**CHAPTER 11**  
**REQUEST FOR WAIVER FROM ACCESSIBILITY REQUIREMENTS**  
**CHAPTER 553, PART V, FLORIDA STATUTES**  
**August 1999**

MODIFICATION PER  
ADA CODE REQUIREMENTS  
CHANGE OF USE

**SLIP N' SLIDE RECORDS**  
919 4TH STREET  
MIAMI BEACH, FL 33139

DRAWING No.  
10-2504 A-1  
SHEET  
A-1

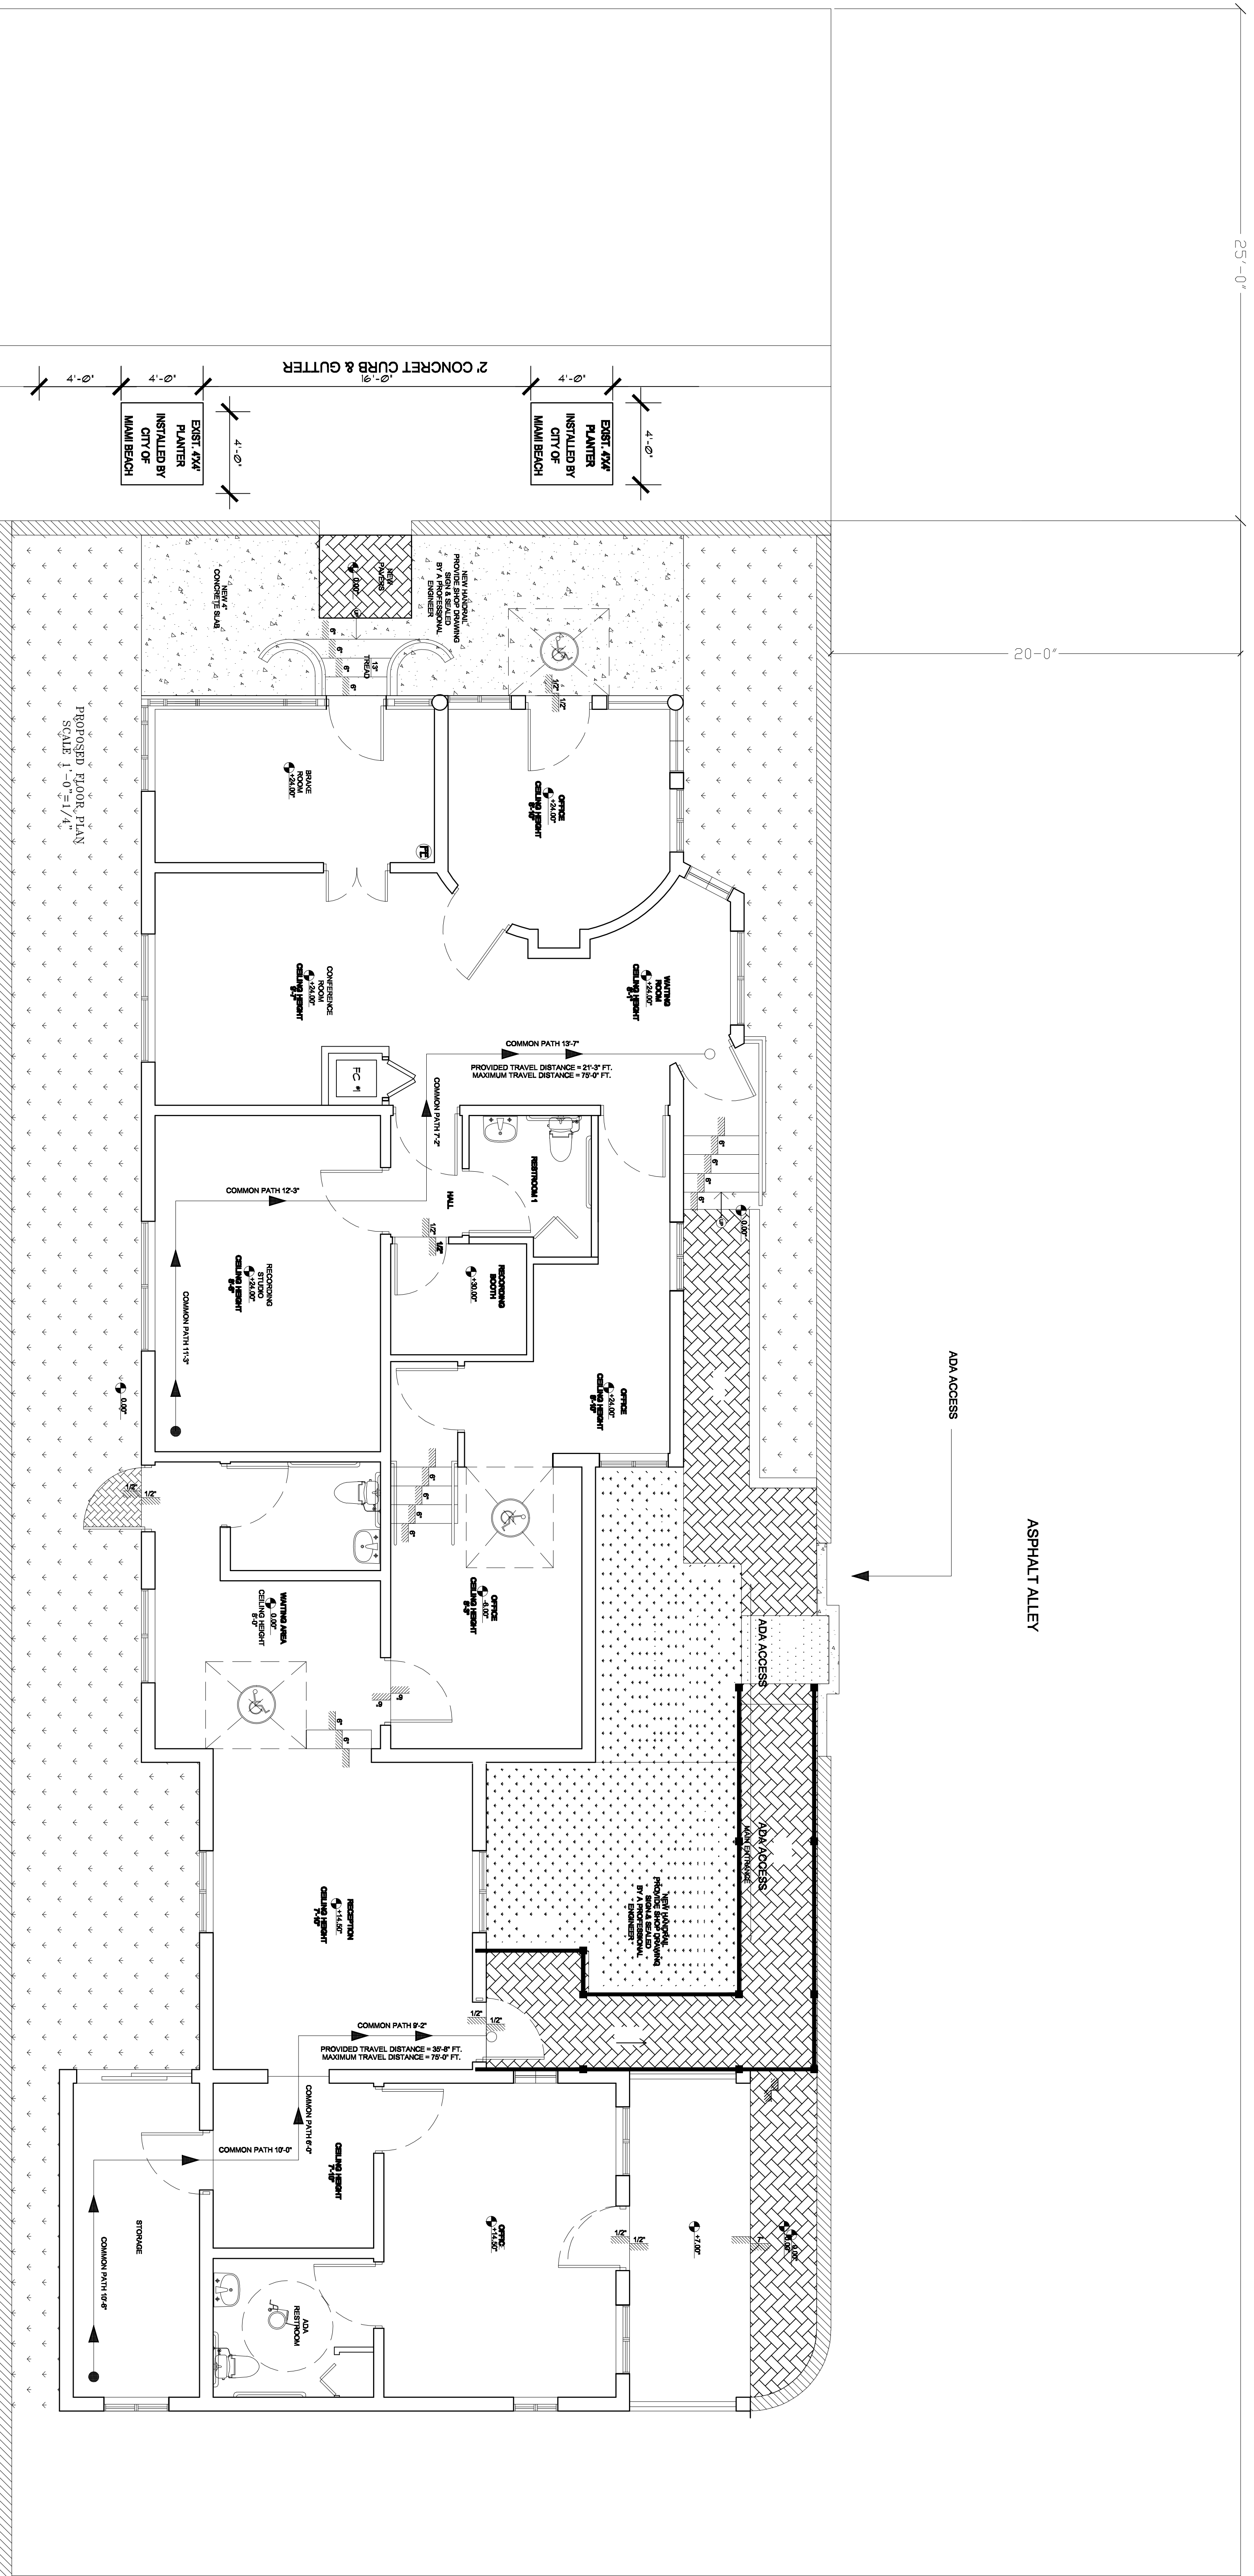
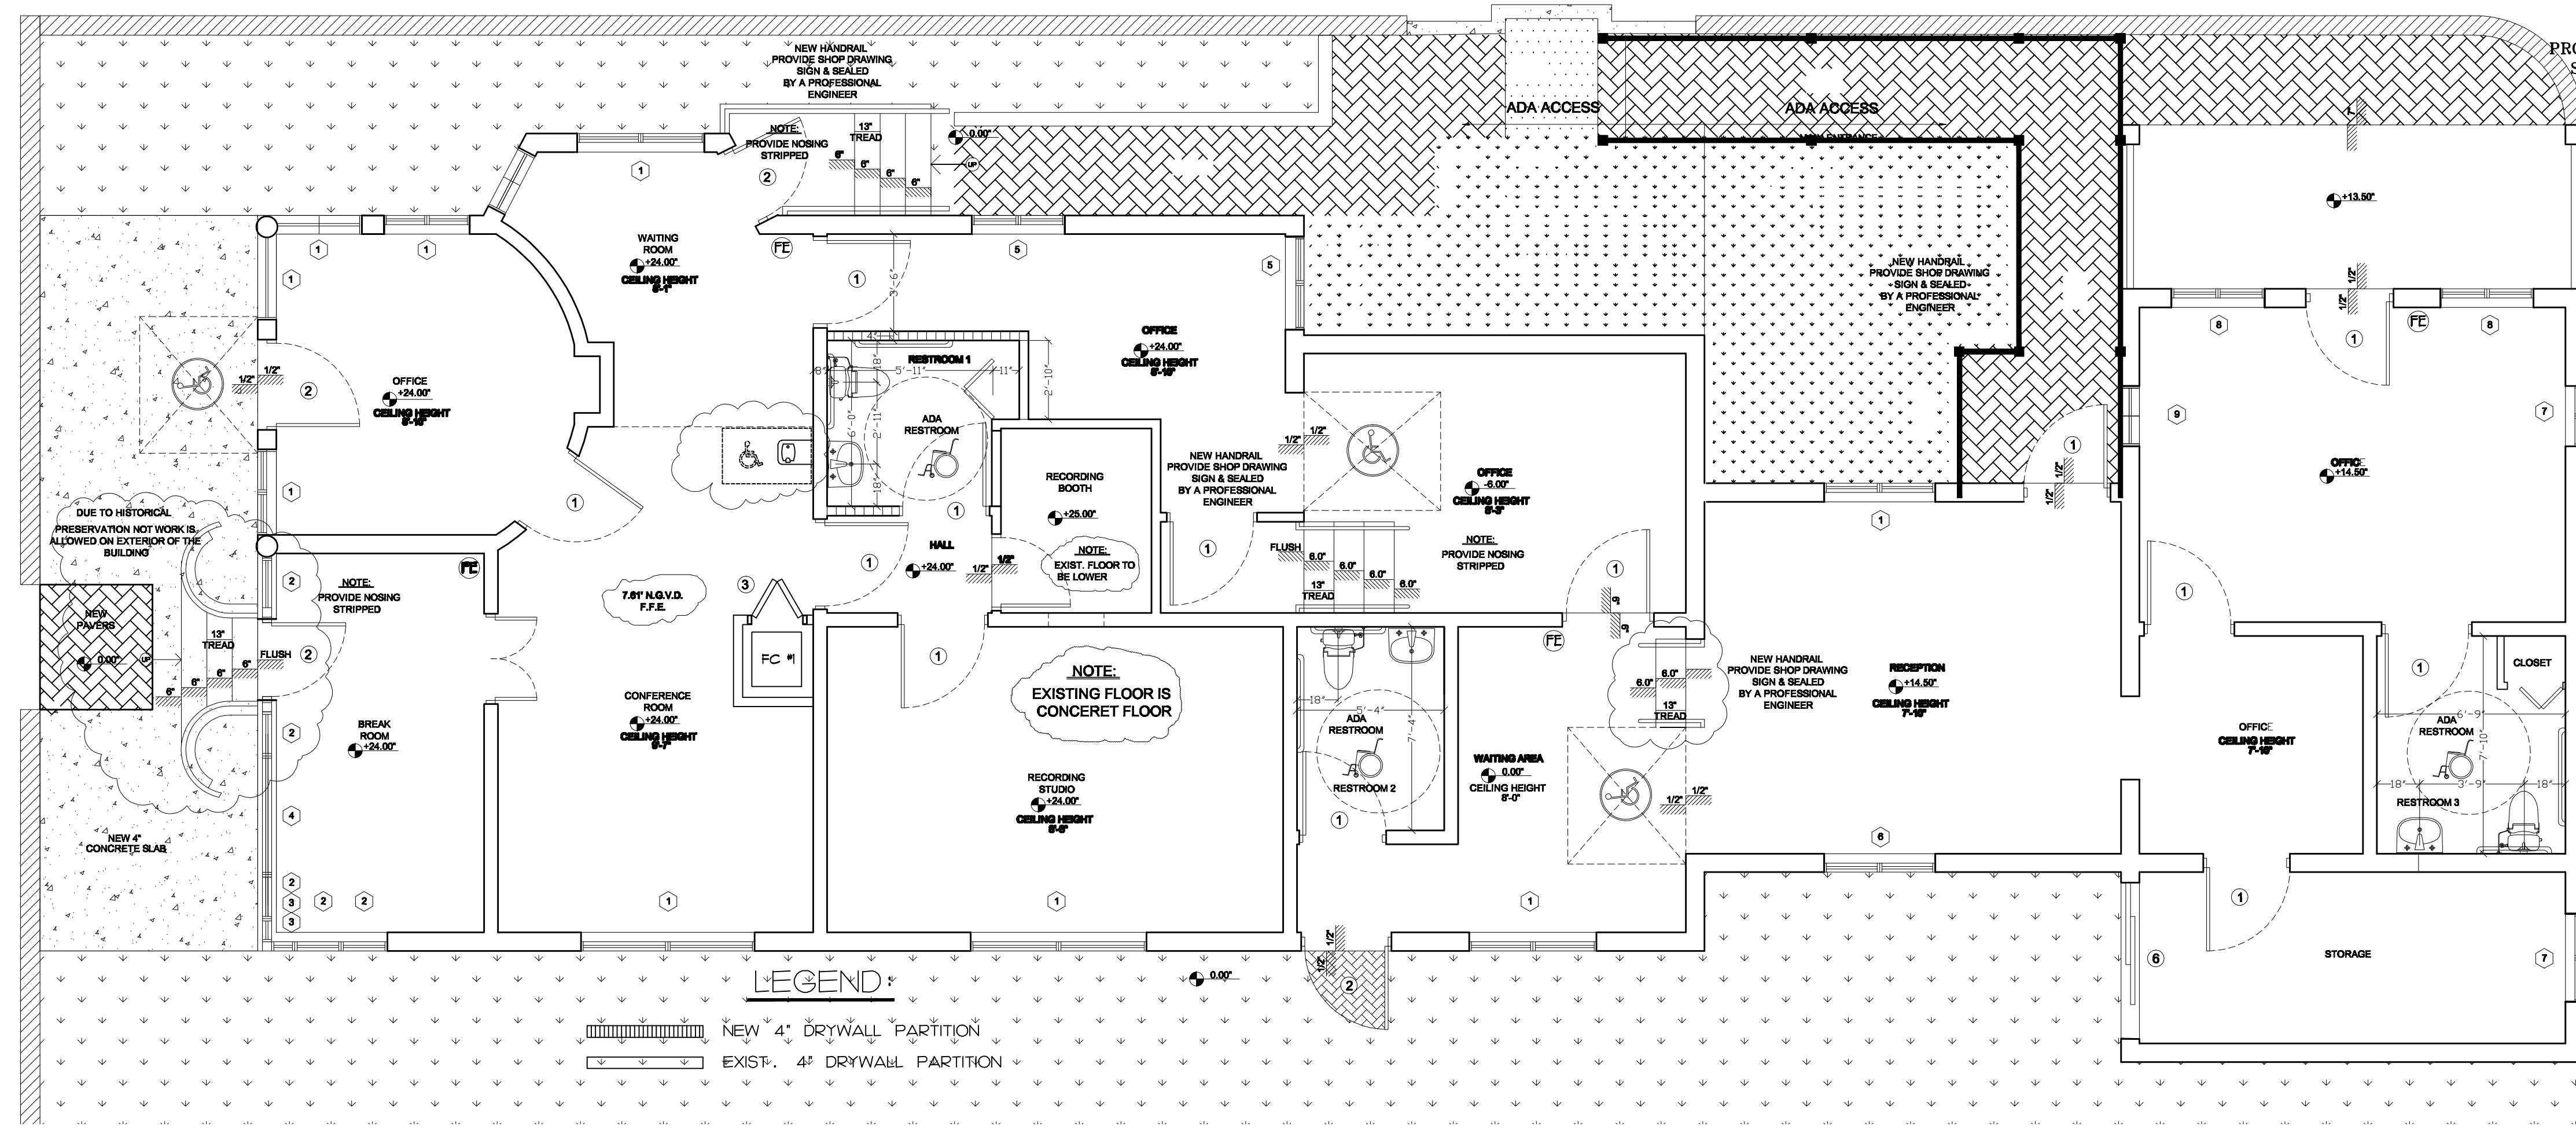
\*COORDINATE FLOOR PLAN (A-1) AND A-3

\*16.-Coordinate Bathroom #3. On floor plan does not show a shower. Show bathroom dimensions and fixture clear floor space. \*SEE ELEVATION ON A-1

sheet a-1:

1. state on plans that design shall comply with the florida fire prevention code 2007 ed chap 39
2. show life safety plan (travel distance,etc)
3. state on plans that all interior finishes shall comply with the florida fire prevention code 2007 ed chap 10 & table a.10.2.2 for business

4. provide occupancy load per the ffpc 07 ed chap 7 for business
5. provide floor elevation across all egress doors,needs to be level on both sides with 1/2" max across the threshold(note: the office door to the unlabeled area, recording booth area are not in compliance)

6. the step that connects the reception area to the unlabeled area(note: label all areas on plans) does not comply with the ffpc 07 ed chap 7 , 3 steps or less shall have a minimum tread of 13" and thier nosing stripped.

7. the "reception step", "break room stairs" do not comply with the ffpc 07 ed 7.2.2.4.1, handrails
8. provide info on the handrails for the main entrance. these handrails shall comply with the ffpc 07 ed

9. the existing drawing shows steps out of the reception area, the new does not, clarify

sheet a-1:

2. show life safety plan (travel distance, etc) (SHEET A-2 PROVIDES THE TRAVEL DISTANCES IN DIAGONAL TRAVEL, THIS DOES NOT COMPLY WITH THE FFPC 07 ED CHAP 7, THE METHOD IS 1' FROM THE MOST REMOTE AREA AND MEASURED AT RIGHT ANGLES, RECTIFY

4. provide occupancy load per the ffpc 07 ed chap 7 for business (PROVIDE THE SQ. FOOTAGE TO DETERMINE THE CORRECT OCCUPANT LOAD)

6. the step that connects the reception area to the unlabeled area (note: label all areas on plans) does not comply with the ffpc 07 ed chap 7, 3 steps or less shall have a minimum tread of 13" and their nosing stripped (PROVIDE NOTE ON PLANS REGARDING THESE STEPS THEIR NOSING BEING STRIPPED)
7. the "reception step", "break room stairs" do not comply with the ffpc 07 ed 7.2.2.4.1, handrails
8. provide info on the handrails for the main entrance. these handrails shall comply with the ffpc 07 ed 7.2.2.4.4

7. the "reception step", "break room stairs" do not comply with the ffpc 07 ed 7.2.2.4.1, handrails (SHOW HANDRAILS FOR ALL STEPS PER THE FFPC 07 ED CHAP 7 ON PLANS)
8. provide info on the handrails for the main entrance. these handrails shall comply with the ffpc 07 ed 7.2.2.4.4

4. provide occupancy load per the ffpc 07 ed chap 7 for business (PROVIDE THE SQ. FOOTAGE TO DETERMINE THE CORRECT OCCUPANT LOAD)
7. the "reception step", "break room stairs" do not comply with the ffpc 07 ed 7.2.2.4.1, handrails (SHOW HANDRAILS FOR ALL STEPS PER THE FFPC 07 ED CHAP 7 ON PLANS)

sheet a-1:

7. the "reception step", "break room stairs" do not comply with the ffpc 07 ed 7.2.2.4.1, handrails(SHOW HANDRAILS FOR ALL STEPS PER THE FFPC 07 ED CHAP 7 ON PLANS)

PROVIDE RAMP RATIO TO VERIFY COMPLIANCE WITH THE FFPC 2010 CHAP 7, MAY REQUIRE HANDRAILS FOR THIS
